# UNITED STATES PATENT AND TRADEMARK OFFICE

APPLICATION NO.	FILING DATE	FIRST NAMED INVENTOR	ATTORNEY DOCKET NO.	CONFIRMATION NO.
10/626,913	07/25/2003	Thomas A. Saldarelli	35451	2415

<b>Office Action Summary</b>	<b>Application No.</b> 10/626,913	<b>Applicant(s)</b> SALDARELLI ET AL.	
	<b>Examiner</b> Steve M Varner	<b>Art Unit</b> 3635

## DETAILED ACTION

FIG. 1

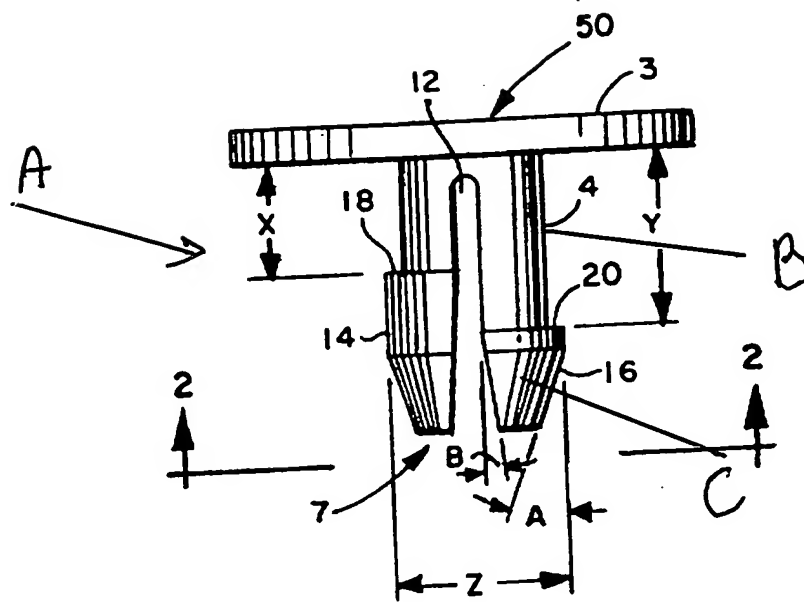
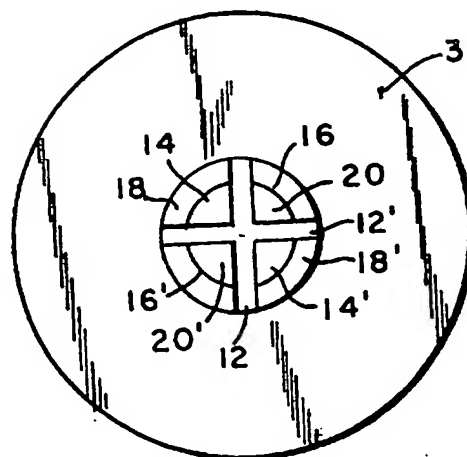
See Fig. 1 attached of Oliver et al.

Regarding claim 7, Oliver et al. shows a base plate insert (A) for use with an axially-elongate tubular anchor body within an anchor assembly for supporting an axially-elongate tubular post, the anchor body having an arcuate interior cross-sectional area, and the tubular post having an arcuate exterior profile and having at least a hollow lower end bounded by an interior surface, the base plate for connection to and closing of one end of the anchor body, the base plate including:

an arcuate portion (B) shaped congruently to the arcuate cross-sectional area of the anchor body for mating into the cross-sectional area of the anchor body; and an upstanding arcuate conical portion (C), the conical portion having a cross-sectional area that is complementary to the hollow lower end of the post and having a greatest radial dimension at a base of the conical portion, the greatest radial dimension being greater than a complementary dimension of the interior surface of the post to cause the interior

surface of the post to slide over the conical portion and the conical portion to frictionally engage the post to prevent lateral movement of the post relative to the base plate.

Regarding claim 8, Oliver et al. shows wherein the arcuate portion (B) of the base plate is circular to mate with a circular cross-section anchor body, and the conical portion (C) of the base plate is a circular conic.

Regarding claim 9, Oliver et al. shows a truncated conic (C) (Fig. 1, 2).

Regarding claim 10, Oliver et al. shows an axially extending opening (12) (Fig. 1, 2)

Regarding claim 11, Oliver et al. shows the base plate has a flange (D) that extends in an outward radial direction from the arcuate portion (B) of the base plate (A) (Fig. 1, 2).
